## **1-9 Oxford Drive – Official Plan and Zoning By-law Amendments Application – Request for Direction Report**

**Date:** January 5, 2023

**Planning Application Number:** 22 114201 WET 05 OZ

## Attachment 5: Site Plan

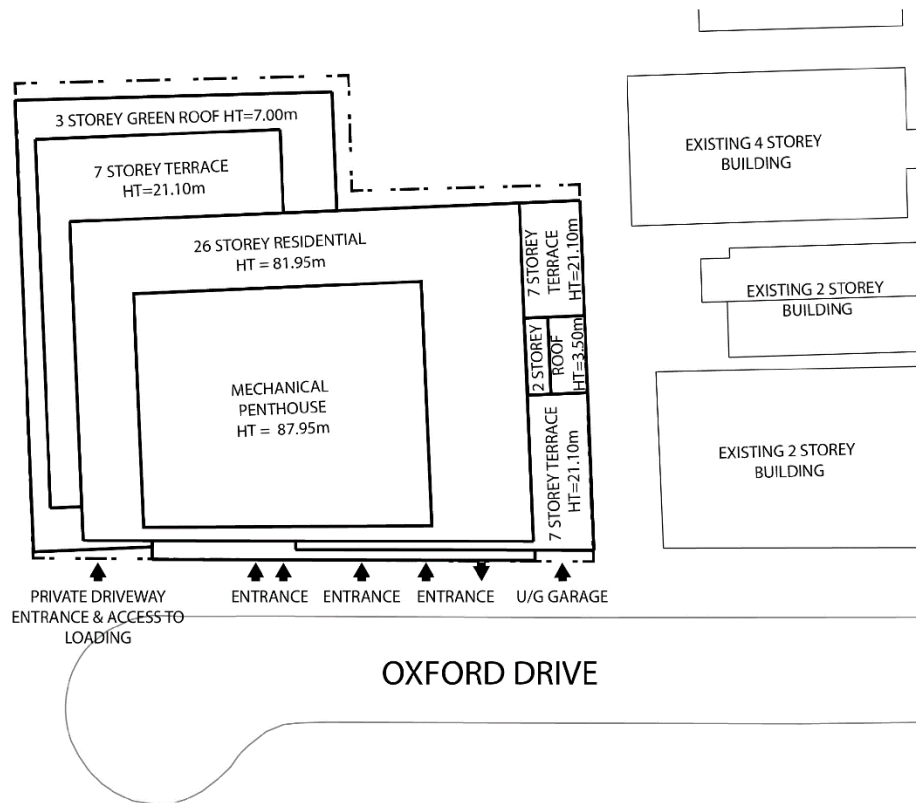
The application proposes a base building of six storeys in height. The base building is proposed to have a front yard setback of zero metres fronting Oxford Drive, a northern side yard setback of zero metres, southern side yard setback of zero metres and a rear yard setback of 1.2 metres. In addition, the application proposes a blank wall along the southern property line towards Weston Road.

The proposed base building portion does not exhibit an appropriate height or appropriate setbacks. In its current form, the base building does not fit harmoniously with the existing or planned context of Oxford Drive, does not conform with the policies of the Official Plan, Mount Dennis Secondary Plan and does not follow the direction of the Tall Buildings Design Guidelines.

The application proposes tower setbacks that are inadequate on all four sides, with a tower setback of only 1.5 metres from the front property line, four metres from the north property line, 4.5 metres from the south property line, 1.2 metres for almost half of the east property line and 11.07 metres for the remainder of the east property line.

Although the site location is planned for mid-rise to tall buildings, this particular site does not have sufficient space to accommodate a tall building that would be compliant with all applicable policies, guidelines and requirements. The Tall Building Design Guidelines indicate that sites that cannot provide the minimum tower setbacks and stepbacks may not be appropriate for tall buildings.

In its current form, the proposal splits the outdoor amenity space between the second and seventh floors. Staff recommend that the portion of outdoor amenity space on the second storey be moved to the ground floor level by replacing the former vehicle access with an outdoor amenity and pet relief zone to create a more comfortable outdoor amenity area.

The development is proposed to be serviced by a driveway connection to Oxford Drive, acting as the primary entrance for both underground parking at the southwest corner of the building and loading at the northwest. The proposed development would provide one Type 'G' loading space which would satisfy the minimum loading requirements according to Zoning By-law 569-2013.

The proposed inadequate building setbacks, grade-related open space and landscaping do not support a comfortable public realm and do not achieve the environmental sustainability and pedestrian connectivity objectives of the applicable policies and guidelines.
